Access Compliance Report

Public Rights-of-Way

(Curb Ramps)

Intersection ID: 16185	Main Street: DORIS_AV	Cross Street: RICHLAND_DR	Location: S
ADA ID: 60621727EDCE	Ramp Type: BlendTrans1	Initial Pass/Fail: Fail	Overall Compliance: No
Severity Score: 8.75			
Codes/Mitigation Info/Possible Solution		Field Measurements/Component Compliance

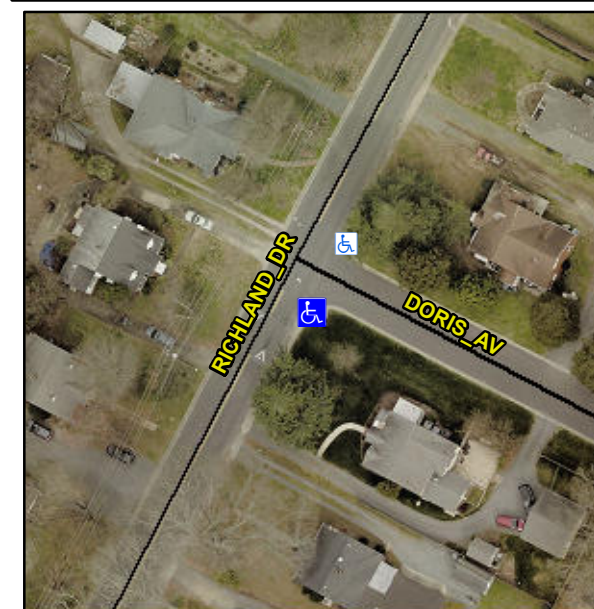
NO LT SW

R304.5.1

Compliance	Description	Data	Compliance	Description	Data
N/A	Ramp Length (in)	61.0	Yes	BlendTrans Slope (%)	1.4
No	Ramp Width (in)	37.0	Yes	BlendTrans XSlope (%)	1.4
N/A	Flare Type LT	N/A	N/A	Flare Type RT	N/A
N/A	Flare Slope LT (%)	N/A	N/A	Flare Slope RT (%)	N/A
N/A	Flare Traversable LT?	N/A	N/A	Flare Traversable RT?	N/A
N/A	Landing Length (in)	N/A	N/A	DWS Provided?	N/A
N/A	Landing Width (in)	N/A	N/A	DWS Contrast?	N/A
N/A	Landing Slope (%)	N/A	N/A	DWS Length (in)	N/A
N/A	Landing X Slope (%)	N/A	N/A	DWS Full Width?	N/A
N/A	Landing Curb? (Y/N)	N/A	N/A	DWS Offset (in)	N/A
N/A	Shared Landing?	N/A			
N/A	Gutter Ponding?	N/A	N/A	Gutter Slope (%)	N/A
N/A	Gutter Lip Ht (in)	N/A	N/A	Gutter X Slope (%)	N/A
N/A	Painted X Walk1?	No	N/A	Painted X Walk2?	N/A
	X Walk 1 Direction	To NE		X Walk 2 Direction	N/A
	X Walk 1 Width (in)	N/A		X Walk 2 Width (in)	N/A
	X Walk 1 Slope (%)	0.2		X Walk 2 Slope (%)	N/A
	X Walk 1 X Slope (%)	3.1		X Walk 2 X Slope (%)	N/A

Remove & Replace Curb Ramp With Two New Directional Ramps or Equivalent.
